NOTICE UNDER SCHEDULE VI CHAPTER XI, RULE 2 (I) OF
THE CITY OF KARACHI MUNICIPAL ACT 1933.

Pursuant to the provision of Schedule VI, Chapter XI, Rule (1) of the City of Karachi Municipal Act 1933. I hereby give you notice that I intend with the meaning of that rule to erect a building on plot No. 18 Survey Sheet S.R. 7. Situated in Surai street Surai Quarter as per Ground plan, Elevation and Section sent herewith in quadruplicate.

Reference No B. S. P. 350/35

With reference to your application dated 22-5-35
with a plan for the proposed building/additions and alterations on plot
No. 13, Survey Sheet No. S.R.9, Serai Quarter
I have to request you to comply with the following requirements:—

PLAN.
 SHOWING PROPOSED BUILDING.
 ON PLOT NO 18, S.R.O.
 SERAI QUARTER.
 SCALE 8"=1"

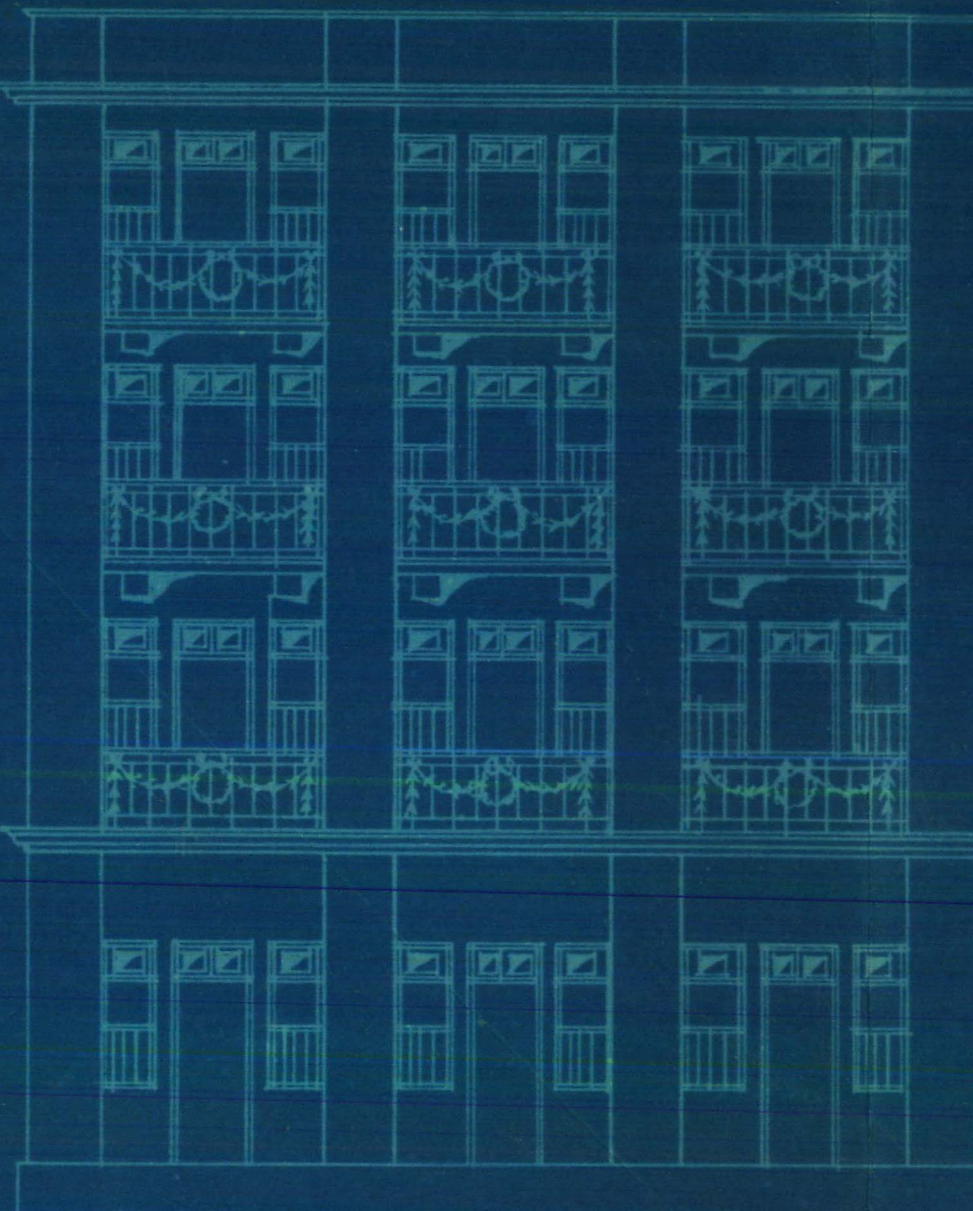
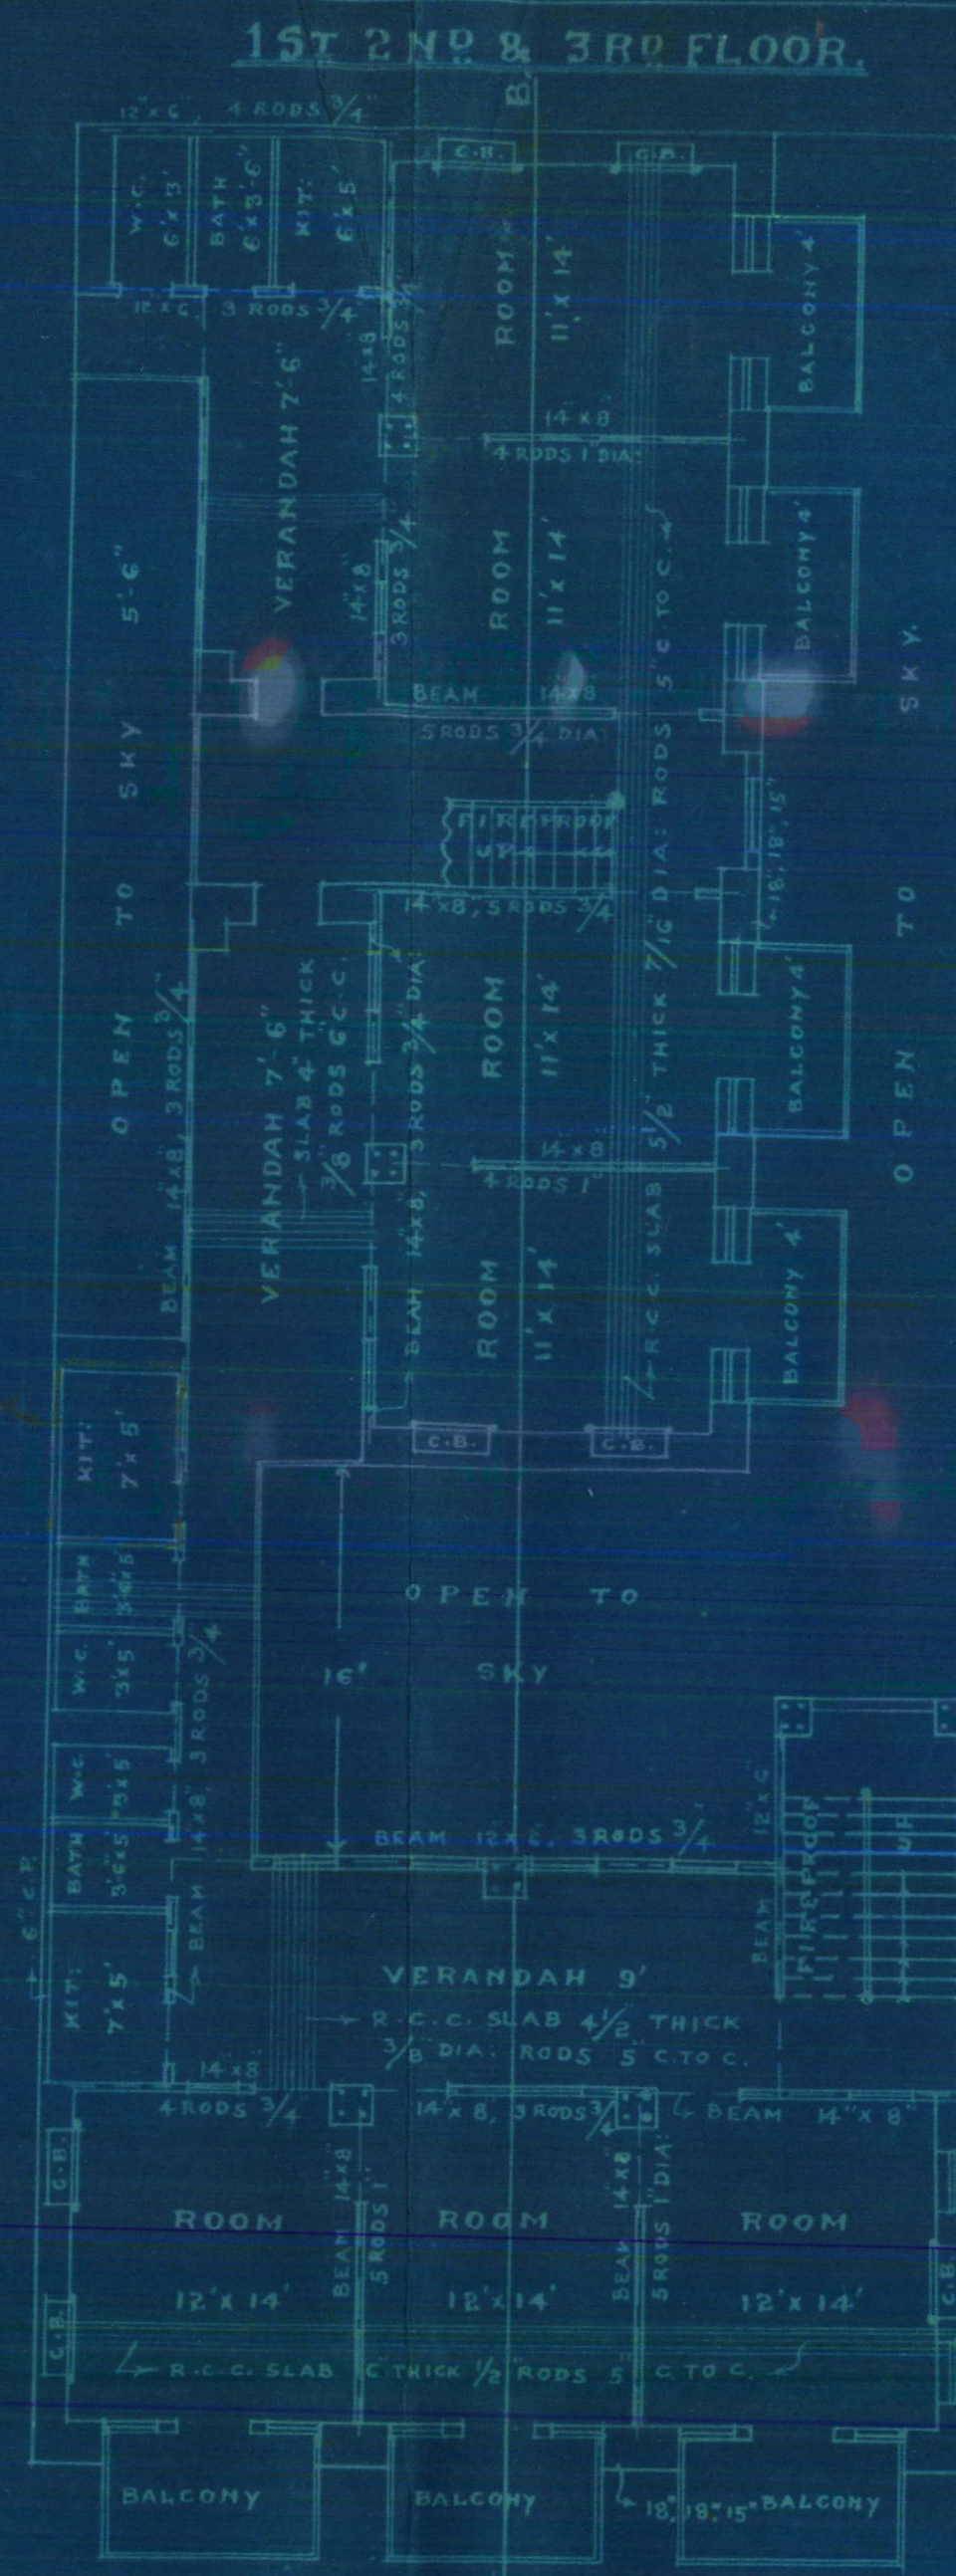
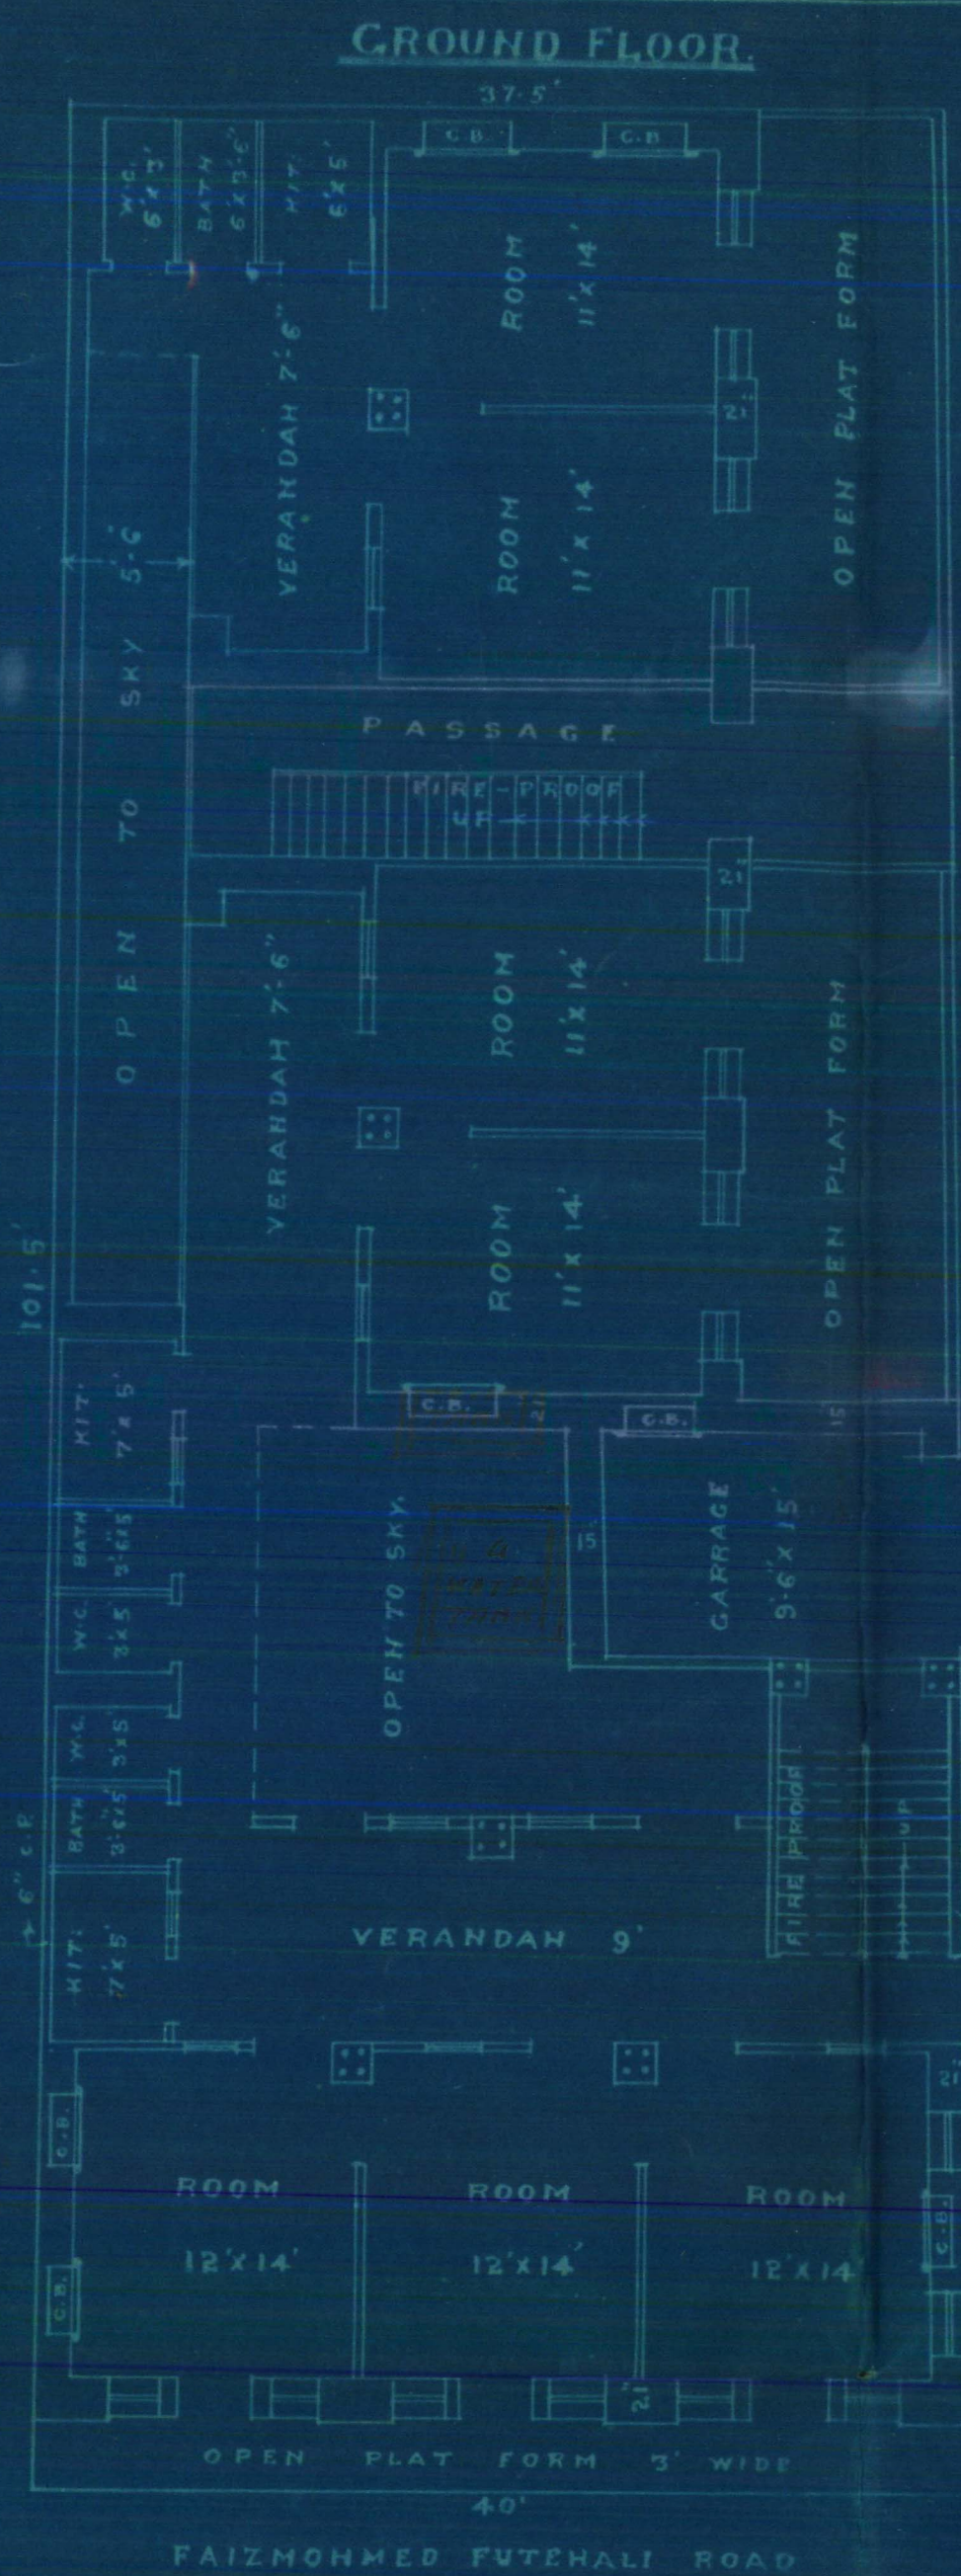
Drainage lines should be shown
on the plan.

- (1) Height to be regulated according to width of street.
- (2) Width of open platform be given.
- (3) Projections of balconies to be limited to 9" on the road-side.
- (4) Central - pillars require to be fully dimensioned.
- (5) Thickness of partitions to be given.
- (6) Thickness of walls for 3rd floor to be 16".
- (7) Width of passage be given.
- (8) Area open to sky be fully dimensioned.
- (9) Plans be signed by the owner.

- ✓ 1. Drainage lines should be shown on the plan.
- ✓ 2. Height to be regulated according to width of streets.
- ✓ 3. Width of open platform be given.
- ✓ 4. Projections of balconies to be limited to 9" on the road side.
5. Central pillars require to be fully dimensioned.
6. Thickness of partitions to be given.
- ✓ 7. Thickness of walls on 3rd floor to be 16".
- ✓ 8. Width of passage be given.
- ✓ 9. Area open to sky to be fully ~~dimensioned~~ dimensioned.
- ✓ 10. Plans to be signed by the owner.

- No objection
1. Drainage line has been shown on the plan.
 2. The height shown on the plan is in accordance with the width of the streets.
 3. Width of the open platform has been shown.
 4. Projections of balconies shown are within the boundary of our plot.
 5. Central pillars have been dimensioned.
 6. Thickness of partitions has been shown.
 7. Thickness of wall on 3rd floor has been made 16".
 8. Width of passage has been shown.
 9. Area open to sky has been dimensioned.
 10. Plans have already been signed by the owner.
